TECHNICAL NOTE

Project Title: St. Stephens Fields, Horsted Keynes

Report Reference: JNY10084 - 04

Application Ref: DM/20/4692- Land South of St. Stephens Church, Hamsland

Figure 01 – Site Access Arrangement – Extract from Road Safety Audit (Drawing No. JNY10084/03)

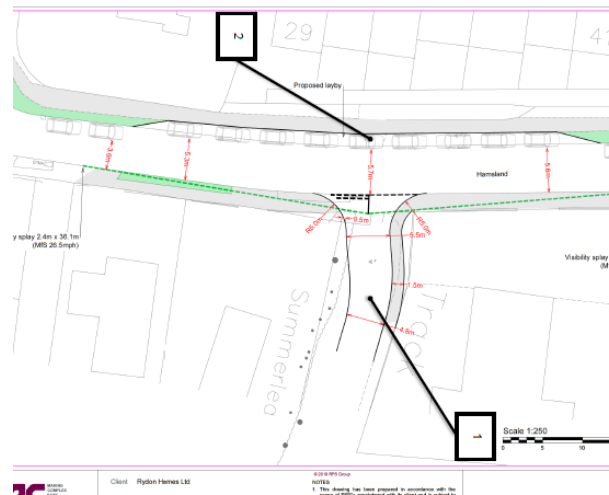
- 1.10 *The RSA raised two issues:*
- 3.1.1 – *Pinch point along access road may lead to collisions. The auditor recommends that tracking is provided for large cars to show that cars travelling in opposing directions can negotiate the pinch point. Designer has responded stating that tracking has been provided and that extent of access road that is 5.5m without narrowing has been extended. The LHA cannot see that tracking specifically for two large cars passing has been provided and therefore advise this is submitted.*
- 1.11 The original layout included the access road narrowing to 4.8m within 15m of the junction with Hamsland (see extract from RSA below).

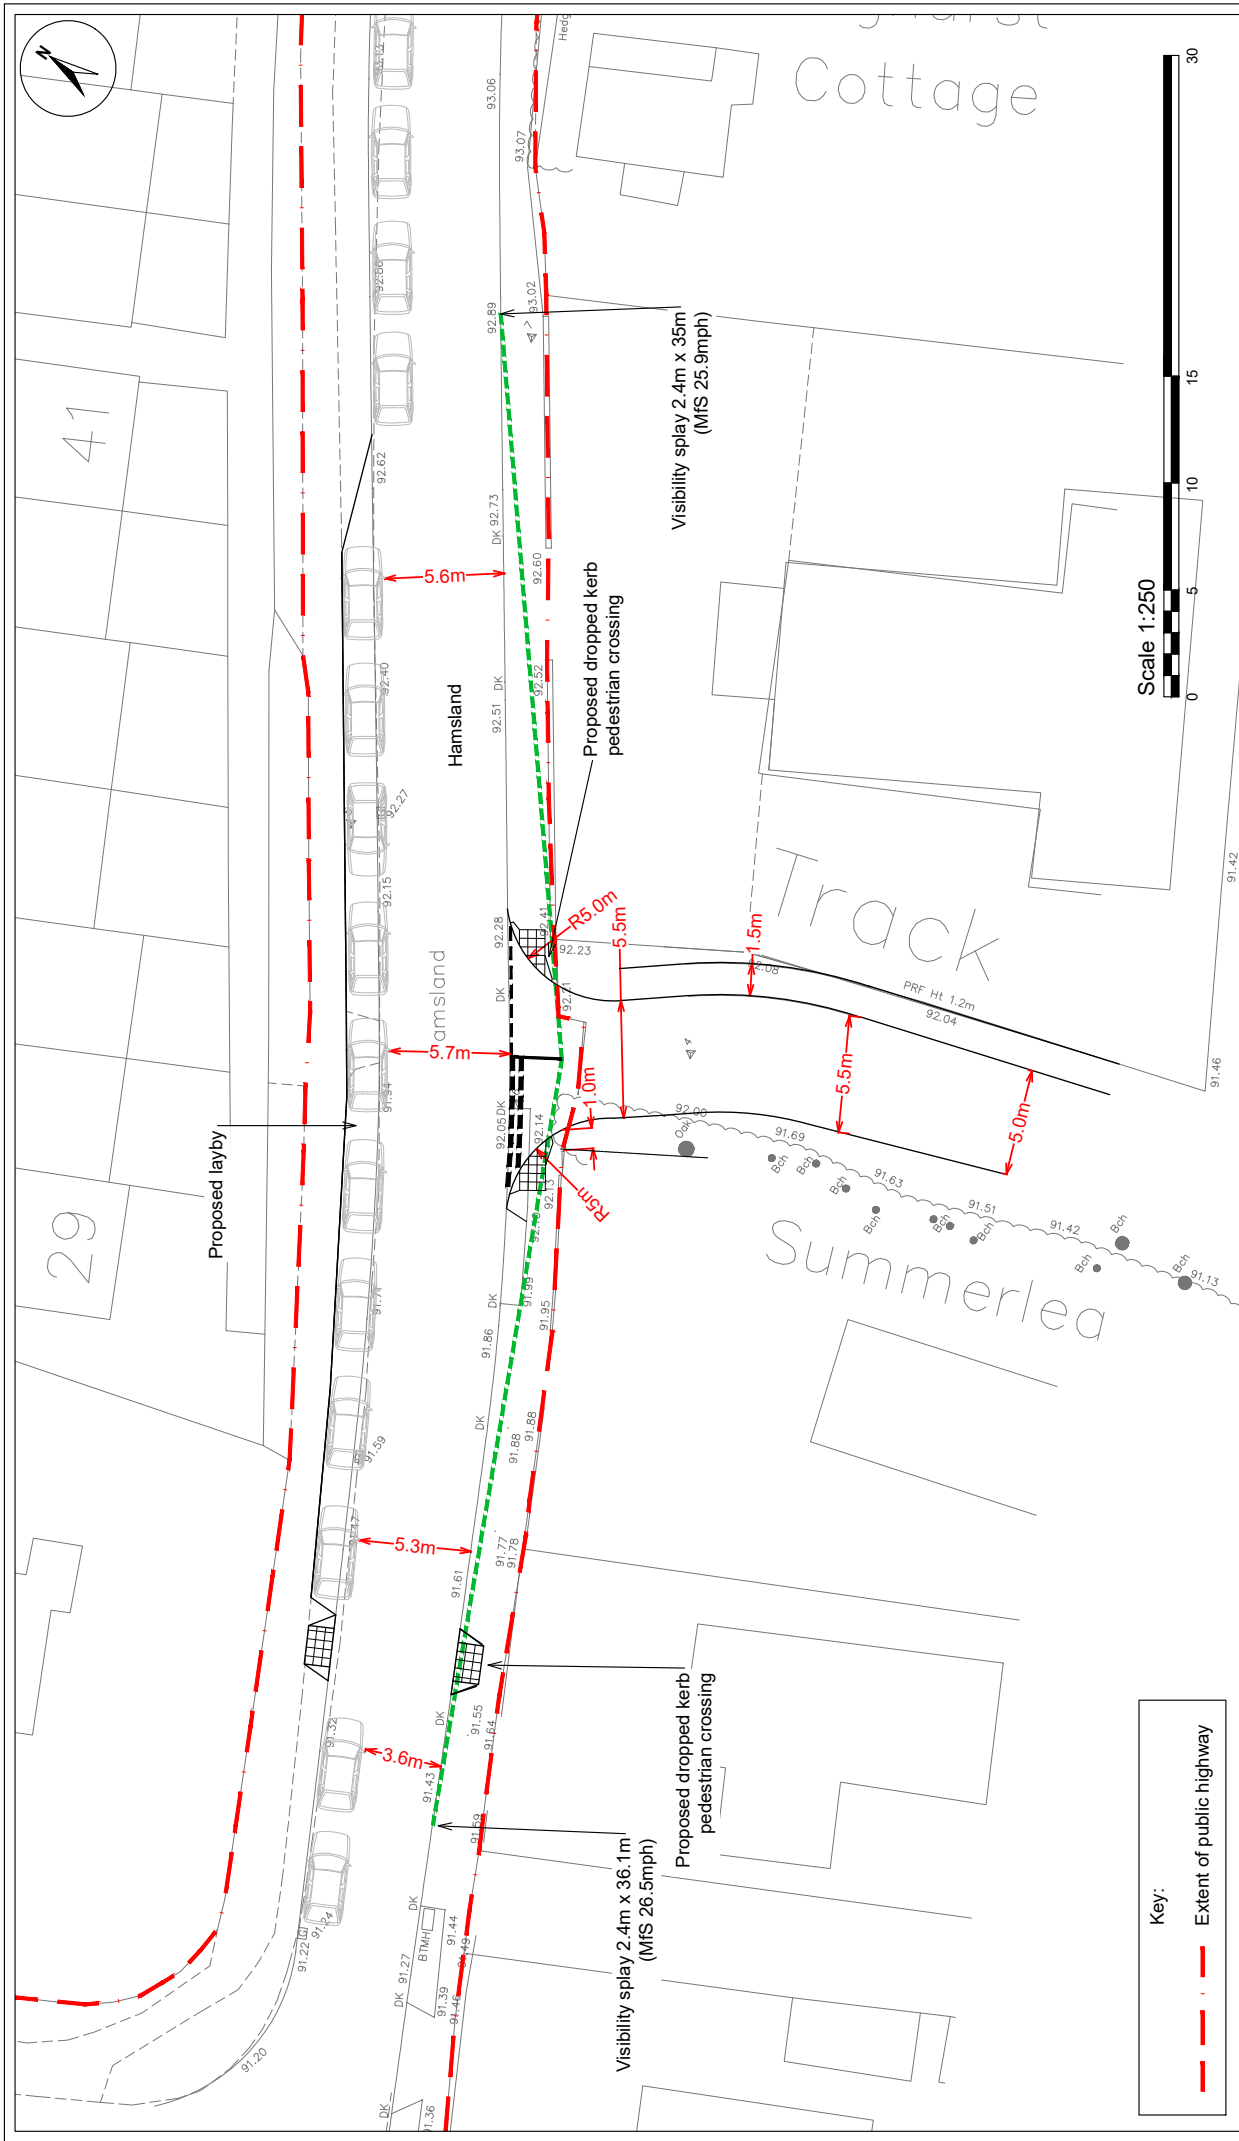
- 1.21 *The TA stated that the parking would be provided in accordance with WSCC parking calculator (2018), however it is understood that this has been superseded by WSCC guidance on Parking at New Developments dated August 2019.*

| 1.24 | The proposed layout is shown to accommodate 54 spaces with an additional 8 spaces within garages. As garage spaces only equal 0.5 spaces in accordance with para 4.14a this results in 4 spaces in garages which brings the total allocated parking provision to 58 . | | | |

- 1.25 In accordance with para 5.8, 0.2 visitor spaces per dwelling needs to be provided. This would mean a total on site provision of **6** visitor spaces. A total of 5 spaces have been identified which equates to 0.17 per dwelling
- 1.26 Overall there is a total of 2 spaces less than the latest guidance which is not considered to be of significant concern.
- 1.27 With regard to cycle parking, it is agreed that this can be conditioned as part of a planning consent.

Client: Rydon Homes Ltd
 Project: St Stephens Fields, Horsted Keynes
 Title: Proposed Site Access
 Visibility Splay

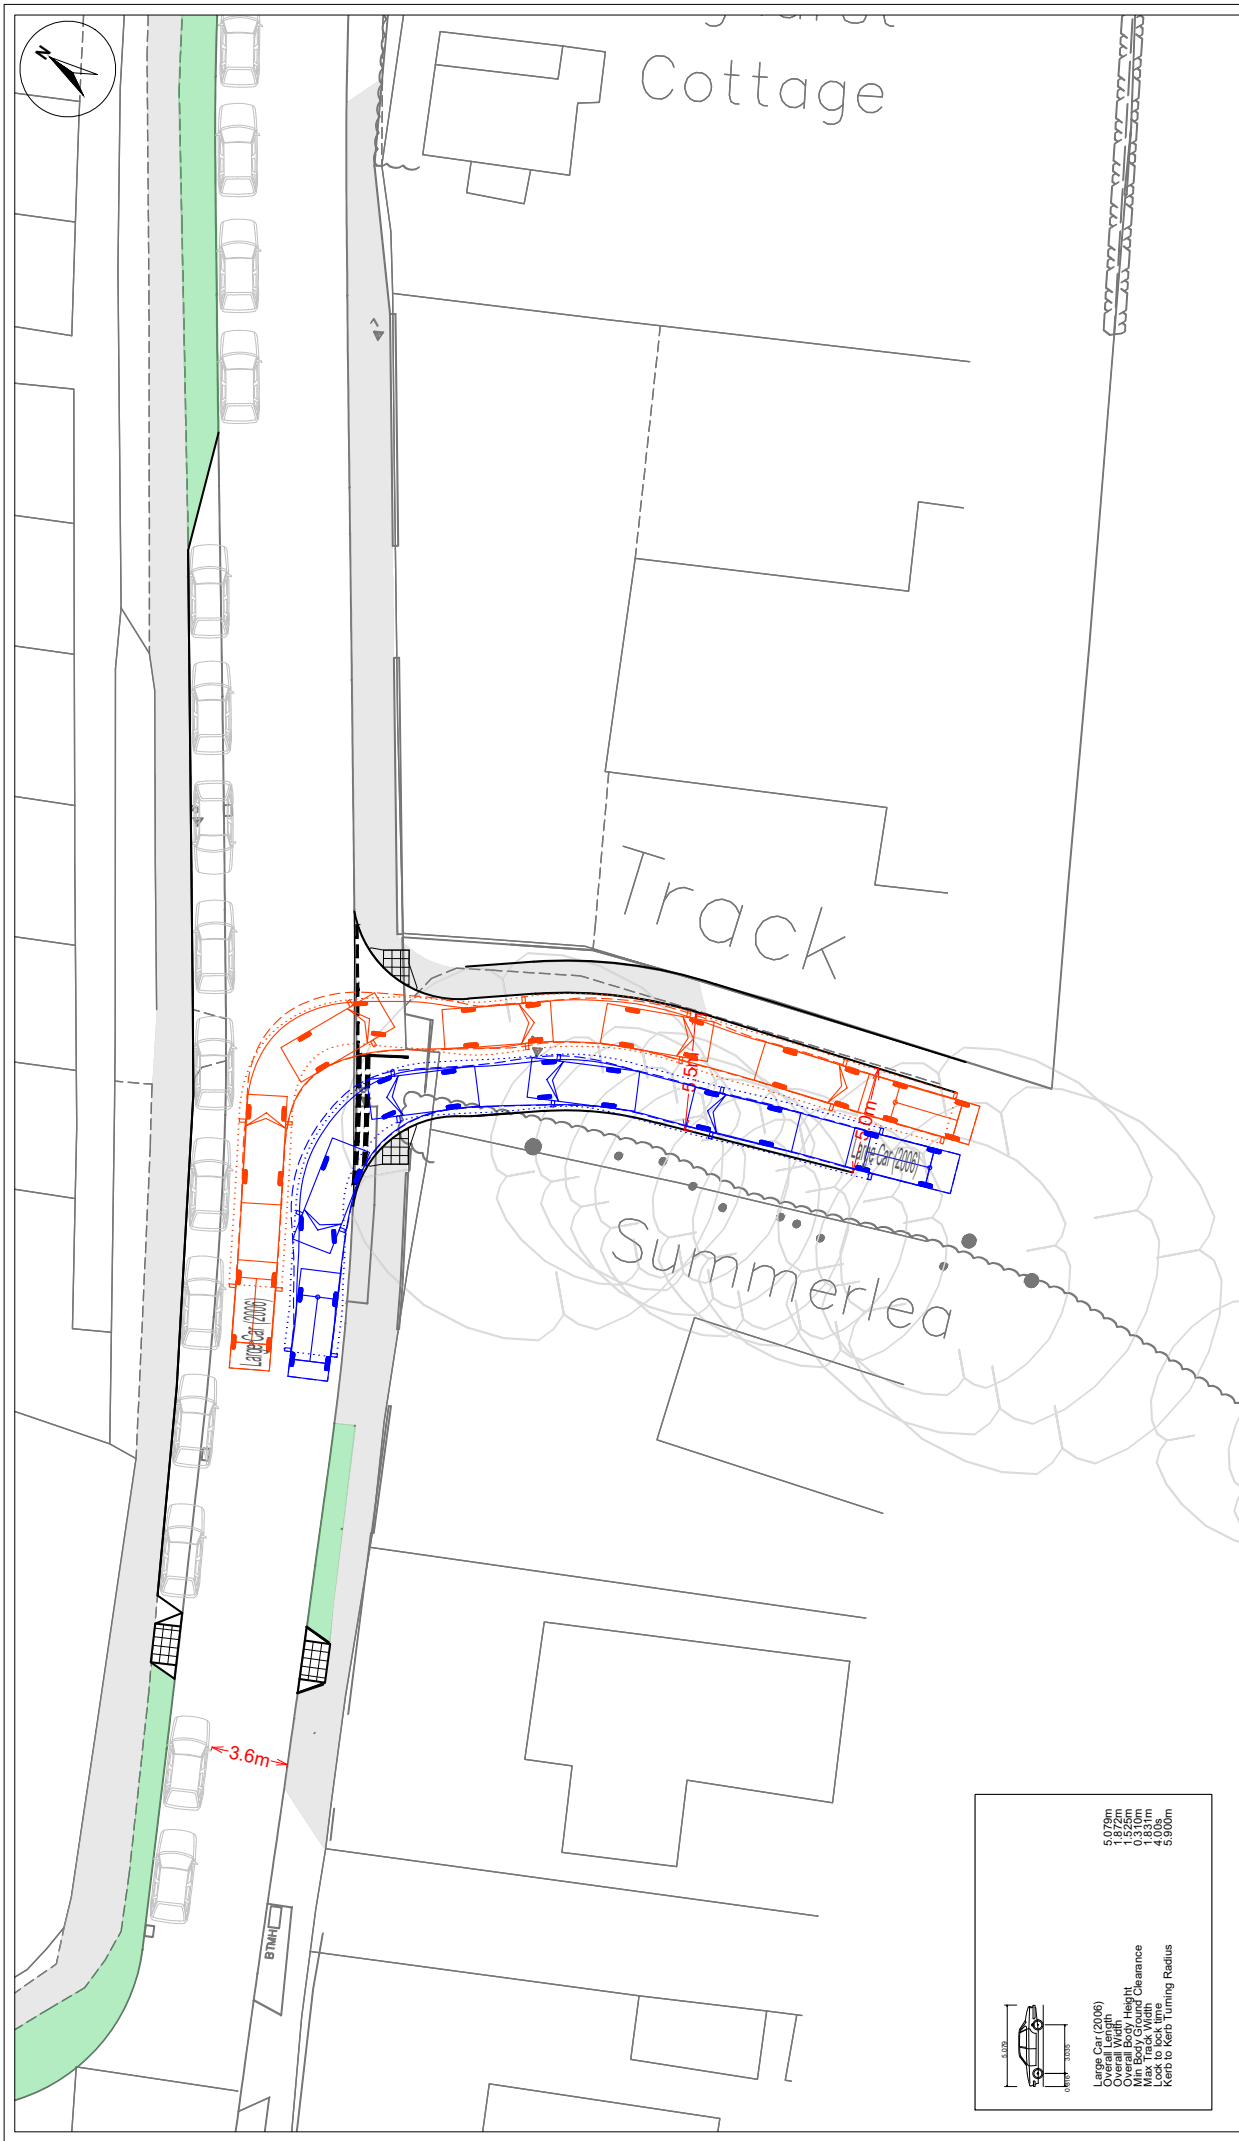
- 1.3 *The TS states that the access road will be shared surface with no segregated footway within the site. As per Manual for Streets (MfS) paragraph 7.2.14, shared surface streets are likely to work well in short lengths (or where they form cul-de-sacs), where the volume of motor traffic is below 100 vehicles per hour and where parking is controlled or it takes place in designated areas. Nevertheless, some of the plans appear to show a 1.5m width footway on the eastern side of the access – the applicant should clarify this point.*

- 1.4 *The access should also feature a dropped kerb tactile paving point either side to allow for pedestrians to utilise the existing footway along Hamsland. This should be reflected on the plans.*

- 1.28 *As per comment above the applicant should confirm whether footway is proposed extending from the site access on the eastern side as some of the plans show this. They should also show a dropped kerb tactile paving crossing across the new junction to enhance connectivity for pedestrians.*

- demonstrate that which ever direction the vehicle approaches, all manoeuvres can be undertaken. A copy of this Swept path analysis is included in **Appendix A**.
- 1.6 The proposal is to provide a formal access arrangement with a 1.5m wide footway as identified on the plan included in the TA. This plan has been updated to include dropped kerbs and tactile paving as advised above. A copy of the updated plan is included in **Appendix A** of this Technical Note.
- 1.7 Within the site, the proposal will include a shared surface arrangement which is shown on Rydon Homes drawing No.1044-FA-201, a copy of which is also included in **Appendix A**.

Rev	Description	By	CB	Date
C	Dropped kerb and tactile added at access and highway boundary added	AJ	MA	30/12/18
B	Access Road width amended	AJ	MA	03/12/20
A	Amendments Made in response to RSA	DA	MA	17/09/20
